# Proposed roundabout concept design on the Oxley Highway and King Creek Road intersection at Wauchope

Community Consultation Report

December 2023

Figure 1: Proposed concept design at the Oxley Highway and King Creek Road intersection, July 2023

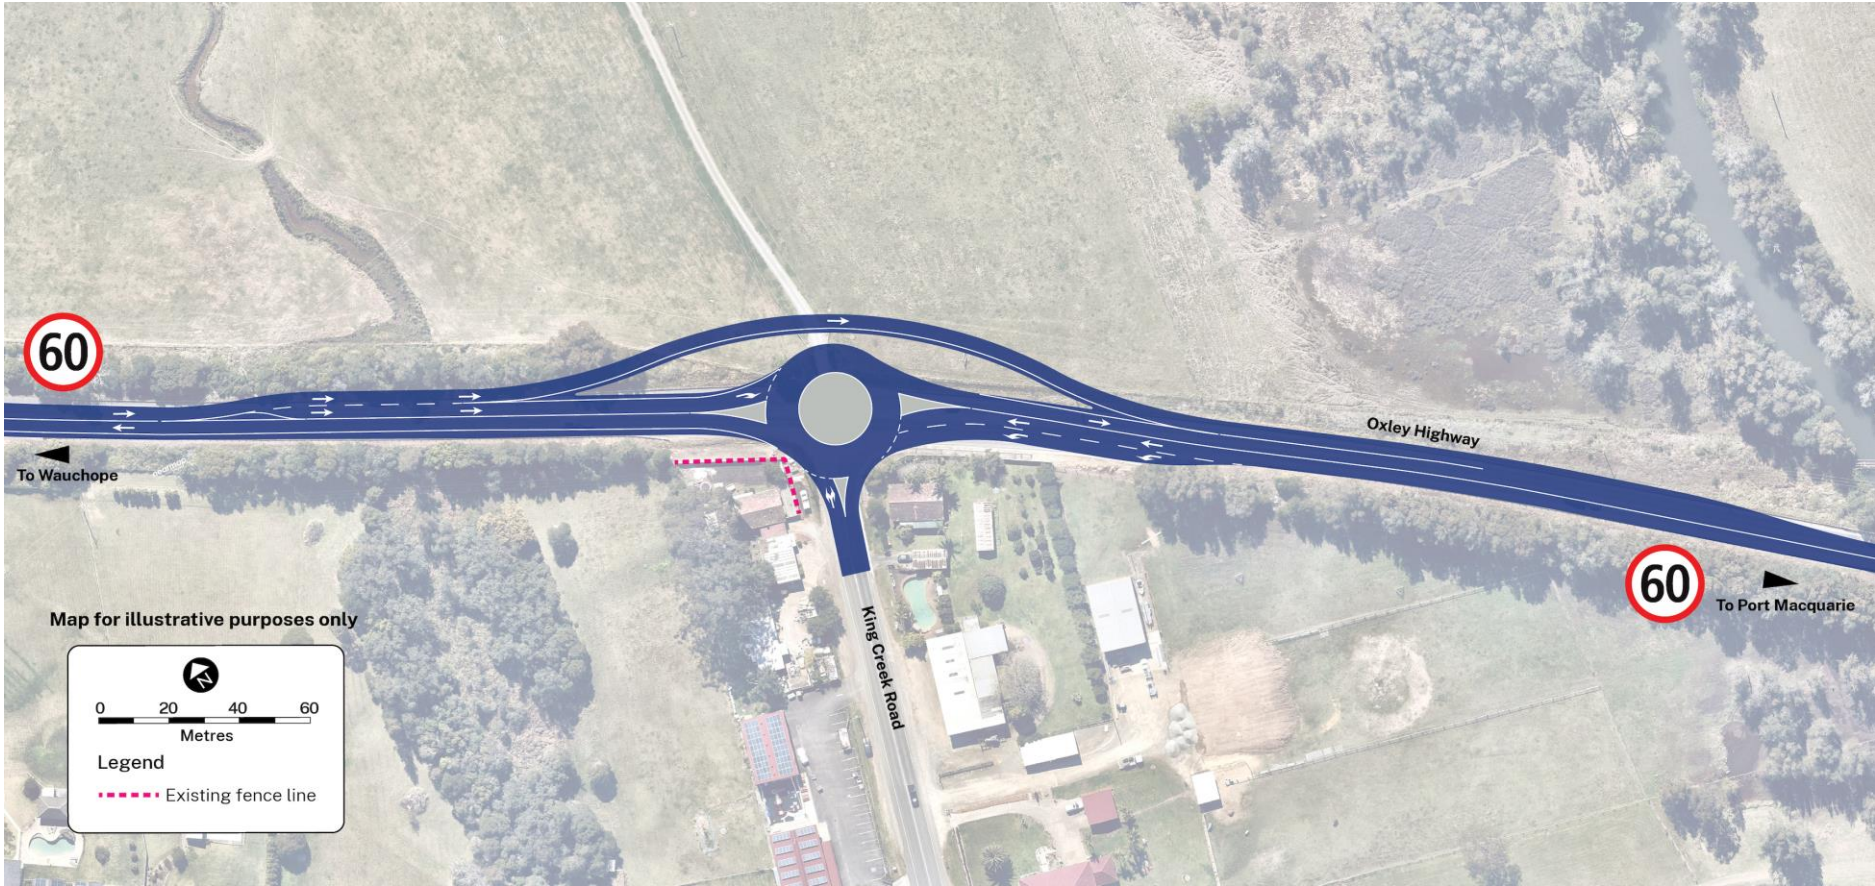
<b>Proposed roundabout (40 comments)</b>		
<ul style="list-style-type: none"> <li>• Traffic impacts           <ul style="list-style-type: none"> <li>○ Turning lane and merge lane are needed.</li> </ul> </li> </ul>	11 comments	A single lane entering the roundabout is provided in King Creek Road. The current delays during morning peaks experienced by traffic turning left are due to traffic waiting to turn right from King Creek Road. This will be alleviated as the roundabout will provide more efficient right turn movements onto the Oxley Highway.
<ul style="list-style-type: none"> <li>○ Need separate left-hand turn lane.</li> </ul>	4 comments	
<ul style="list-style-type: none"> <li>○ Will cause congestion / bottleneck.</li> </ul>	17 comments	
<ul style="list-style-type: none"> <li>○ Doesn't address traffic heading to Wauchope.</li> </ul>	1 comment	Traffic modelling of the proposed roundabout and eastbound slip lane treatment shows improved traffic efficiency without excessive queuing of traffic. Traffic modelling has been undertaken allowing for current and future peak traffic volumes.

<ul style="list-style-type: none"> <li>• Design and construction <ul style="list-style-type: none"> <li>○ The roundabout needs to be a proper/larger roundabout.</li> </ul> </li> </ul>	<p>3 comments</p>	<p>The layout of the roundabout has been designed to restrict drivers to a safe speed on entry and to provide adequate sight distance to approaching traffic and traffic on the roundabout to enable a safe gap to be observed to enter the roundabout and turn left onto the Oxley Highway.</p> <p>The proposed roundabout and eastbound slip lane at the King Creek Road and Oxley Highway intersection, rather than a larger roundabout, is the preferred option considering factors such as reducing the likelihood and severity of crashes, reducing environmental impacts and minimising the area of property acquisition required, maintaining overall network efficiency, constructability and impact to normal operations during construction, funding, cost comparison, utility disturbance and whole of life costs.</p> <p>The size and layout of the roundabout also helps to slow drivers on the approach to the roundabout and restrict drivers to a safe speed on entry to the roundabout. The roundabout proposed is not considered a small roundabout as it caters to B double movements on the Oxley Highway and 19m semi-trailer turning movements in and out of King Creek Road and has been designed in accordance with the Austroads Australian standards to cater to the vehicles listed above.</p>

<ul style="list-style-type: none"> <li>○ Roundabout is too small to address safety.</li> </ul>	3 comments	efficiency without excessive queuing of traffic for the intersection. Traffic modelling has been undertaken allowing for current and future peak traffic volumes.
<ul style="list-style-type: none"> <li>○ Safety will not improve when turning right onto highway.</li> </ul>	1 comment	<p>A well-designed roundabout is the safest form of intersection control. Numerous ‘before and after’ type studies have shown that, in general, fewer motor vehicle crashes resulting in casualty crashes occur at roundabouts than at intersections containing traffic signals, stop, or give-way signs. The primary reason for the improved safety record for motor vehicles is that the relative speeds of vehicles are considerably lower at a well-designed roundabout than for other types of at-grade intersections.</p> <p>Roundabouts have the lowest severity impacts and least number of conflict points compared to other standard intersection treatments, such as the existing layout, which has all types of possible high severity conflicts. The eastbound zip merge is also a low severity conflict point due to the low speed and vehicles travelling in the same direction.</p>

<ul style="list-style-type: none"> <li>○ A small roundabout is a real safety concern with trucks and b-doubles, heavy vehicles and caravans</li> </ul>	1 comment

<ul style="list-style-type: none"> <li>○ Need a left turn lane to not block line of sight from those trying to go eastbound.</li> </ul>	1 comment	
<ul style="list-style-type: none"> <li>○ Heavy vehicles and cars block view when turning out of King Creek Road.</li> </ul>	1 comment	Transport for NSW acknowledges that at times the line of sight of a vehicle waiting to turn right from King Creek Road maybe partially obstructed by a vehicle using the left turn lane into King Creek Road. However, based on the volume of traffic turning left into King Creek Road this is expected to be infrequent

<ul style="list-style-type: none"> <li>○ Westbound left turn lane into King Creek Road should be removed.</li> </ul>	2 comments	and the timeframe for the partial obstruction to clear will be short (seconds).
<b>Efficiency for vehicles exiting King Creek Road (30 comments)</b>		
<ul style="list-style-type: none"> <li>• Traffic           <ul style="list-style-type: none"> <li>○ Cause and create congestion.</li> <li>○ Will frustrate drivers.</li> <li>○ Roundabout will restrict traffic movements out of King Creek Road.</li> <li>○ Only a short-term fix as community grows.</li> <li>○ Left turn out of King Creek Road will still be impacted by westbound traffic.</li> </ul> </li> <li>• Design and construction           <ul style="list-style-type: none"> <li>○ Roundabout will not improve efficiency or safety.</li> </ul> </li> </ul>	14 comments  2 comments  6 comments  3 comments  3 comments   1 comment	<p>Currently the right turn from King Creek Road to the Oxley Highway experiences significant delays in the morning peak of up to two minutes with queues for right turning traffic regularly exceeding 100m resulting in safety issues from driver frustration and risk taking. Traffic modelling of the proposed roundabout and eastbound slip lane treatment shows an improved efficiency without excessive queuing of traffic for the intersection based on traffic volumes at this location on the Oxley Highway. Traffic modelling has been undertaken allowing for current and future peak traffic volumes.</p> <p>A well-designed roundabout is the safest form of intersection control. Numerous ‘before and after’ type studies have shown that, in general, fewer motor vehicle crashes resulting in casualty crashes occur at roundabouts than at intersections containing traffic signals, stop, or give-way signs. The primary reason for the improved safety record for motor vehicles is that the relative speeds of vehicles are considerably lower at a well-designed roundabout than for other types of at-grade intersections.</p>
